Huntington County Community School Corporation Riverview Middle School Student Pick Up Lane Project

Project # 2025.0011

ADDENDUM NO. A-1

Huntington County Community School Corporation Riverview Middle School Student Pick Up Lane Project Pre-Bid Meeting Minutes

C2.0

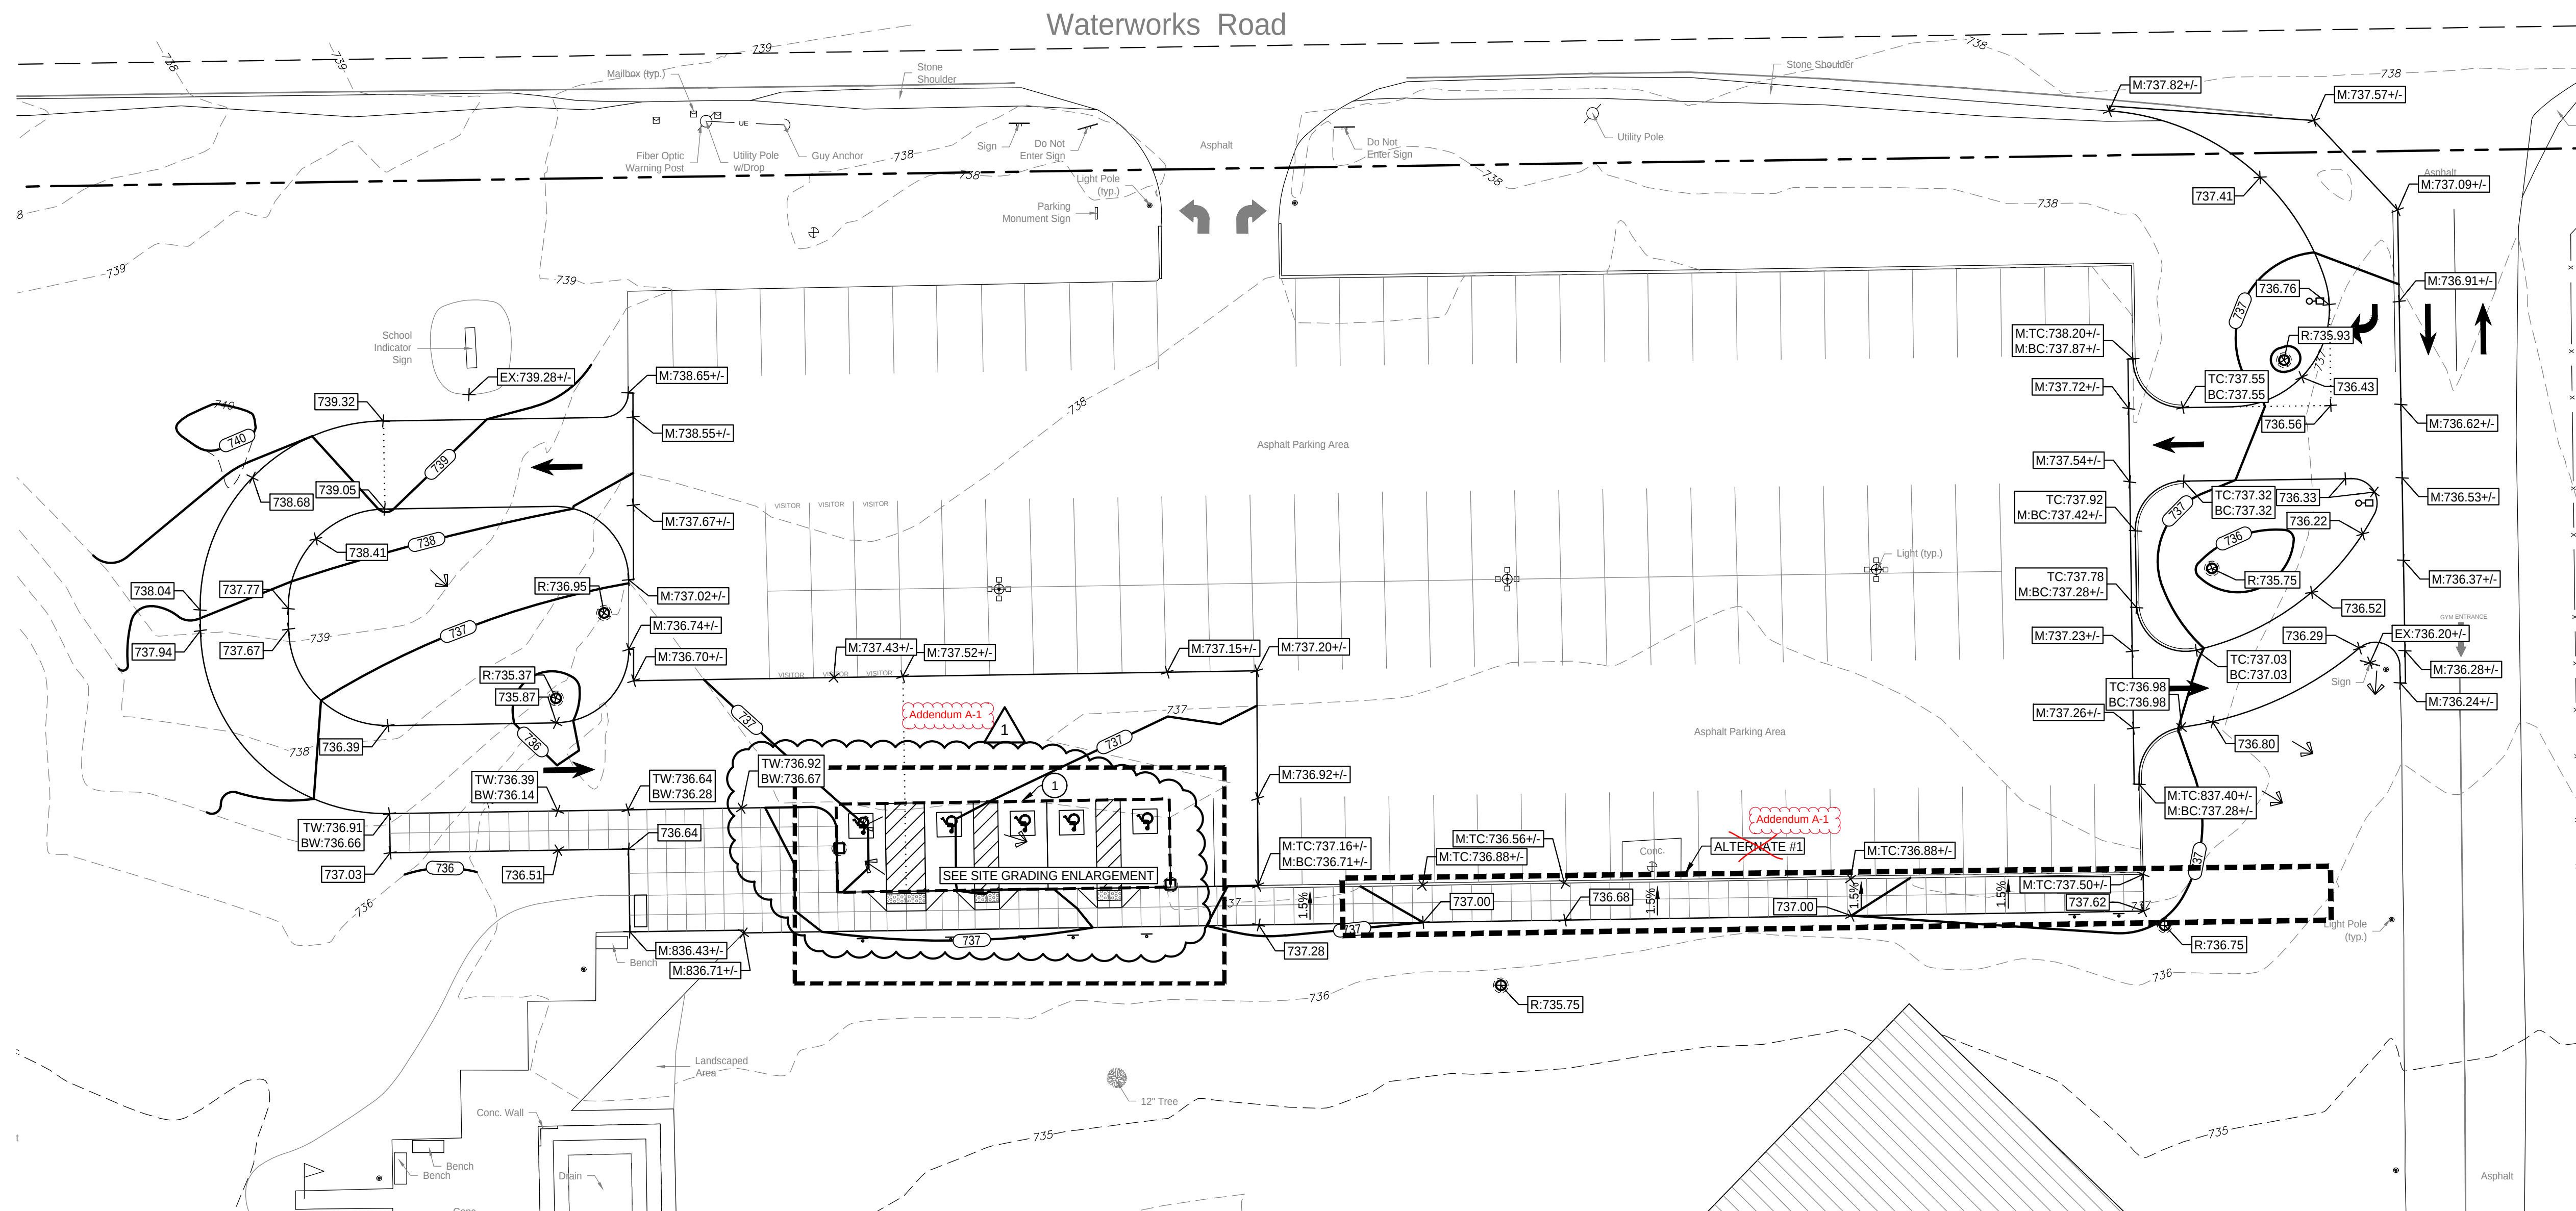
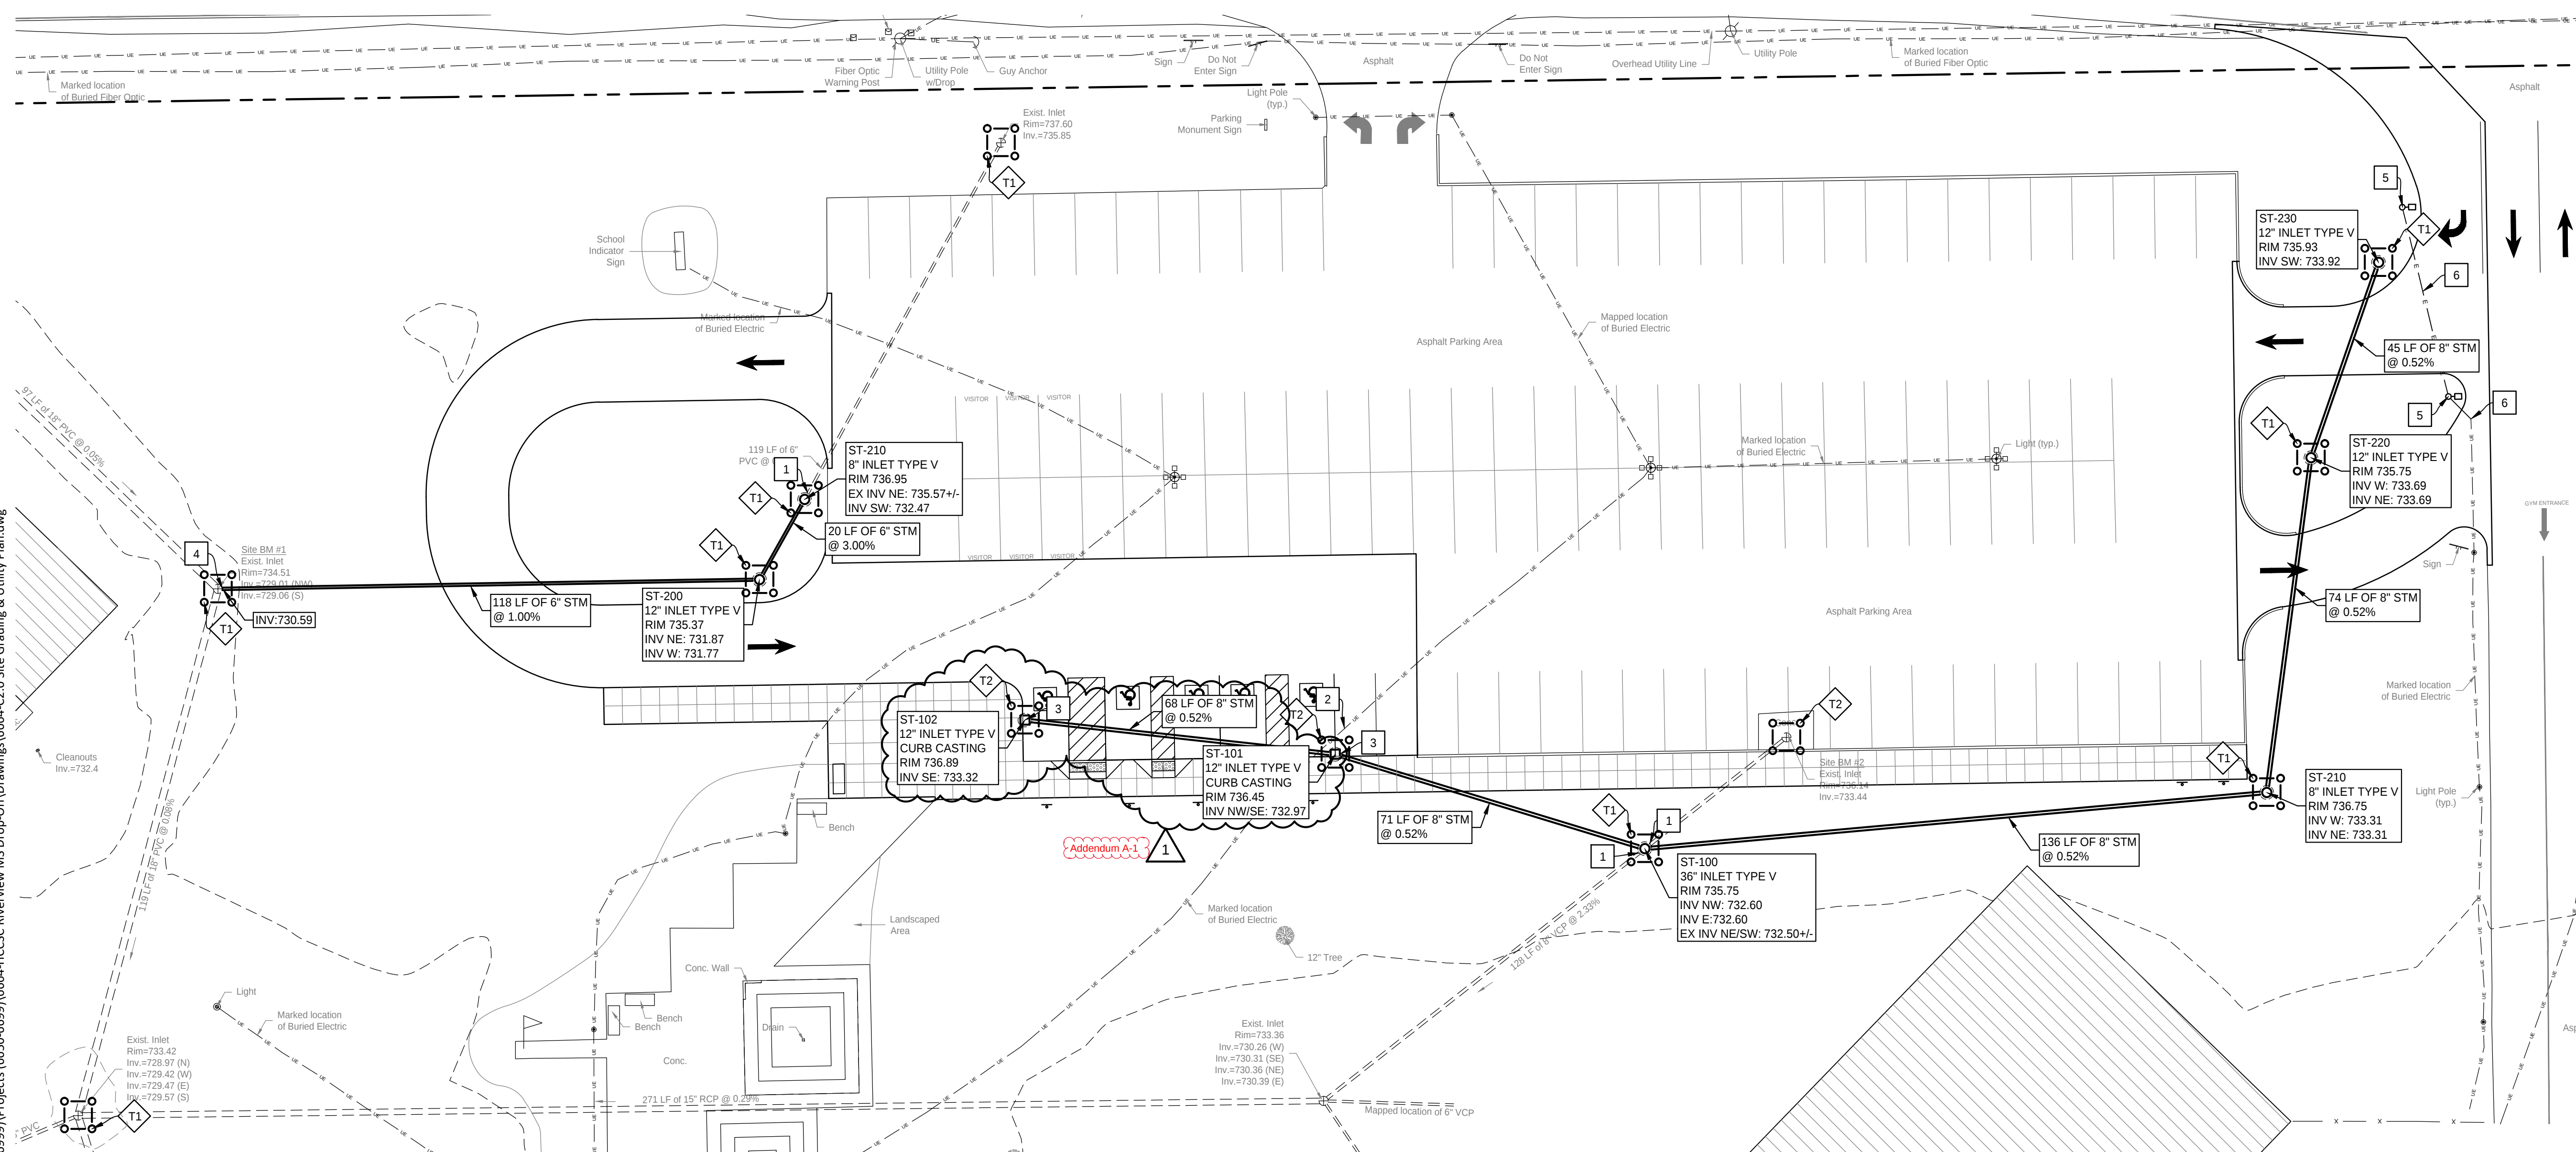
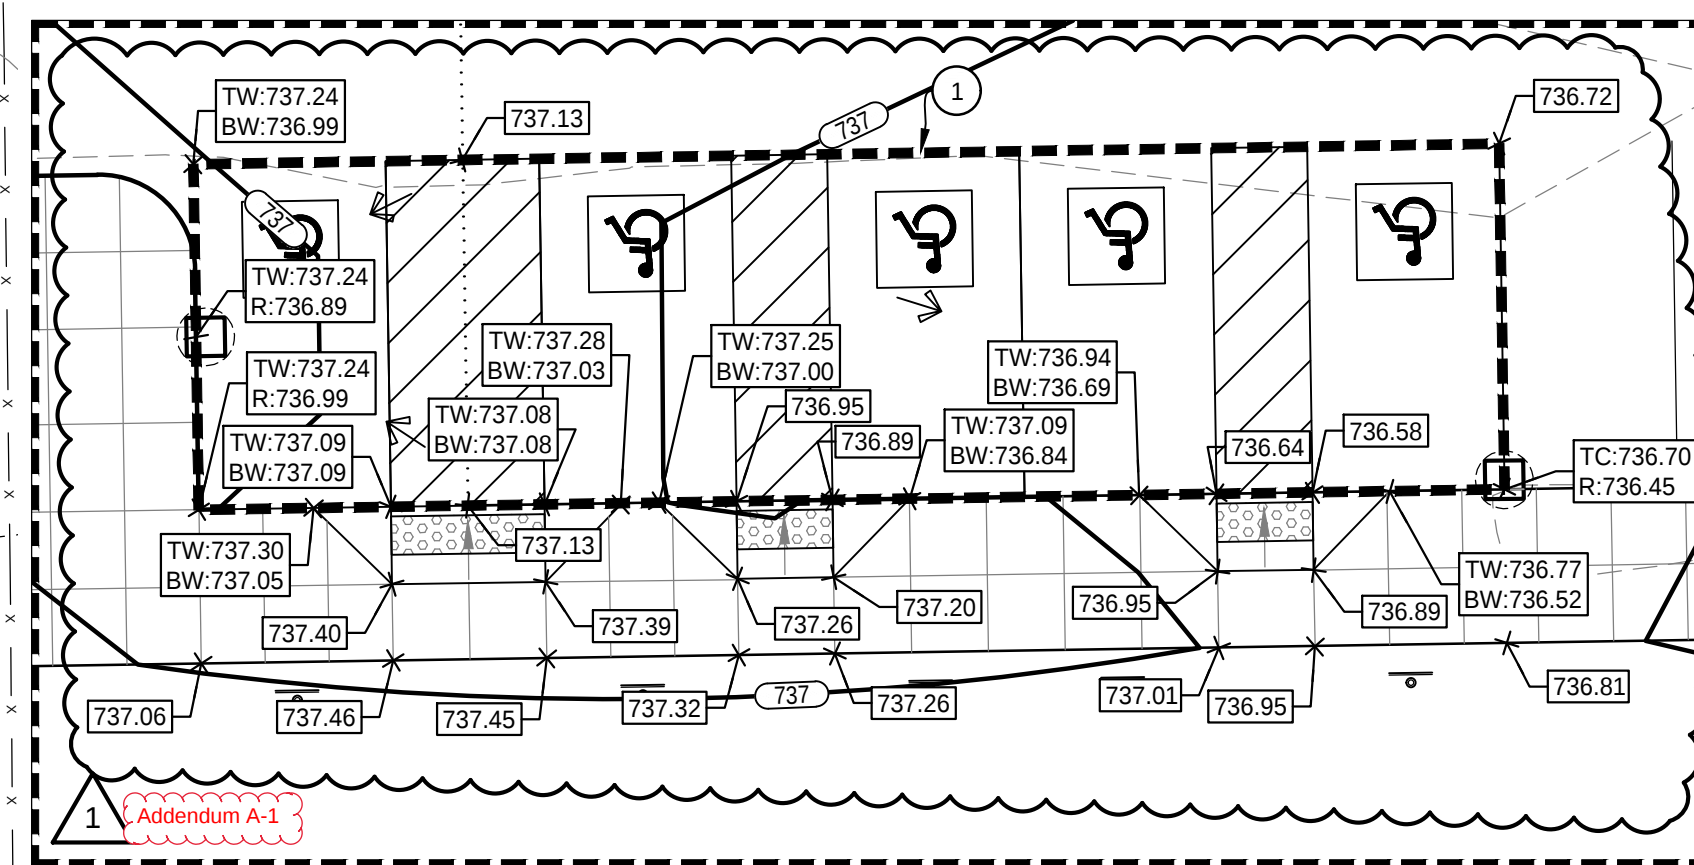
- Sheets C1.0, C2.0 New Parking space layout - REVISED

- Additional Accessible Parking Space and curb cut at sidewalk added.
- Parking layout revised.

- Detail 3 / C2.0 Additional Storm Inlet added.
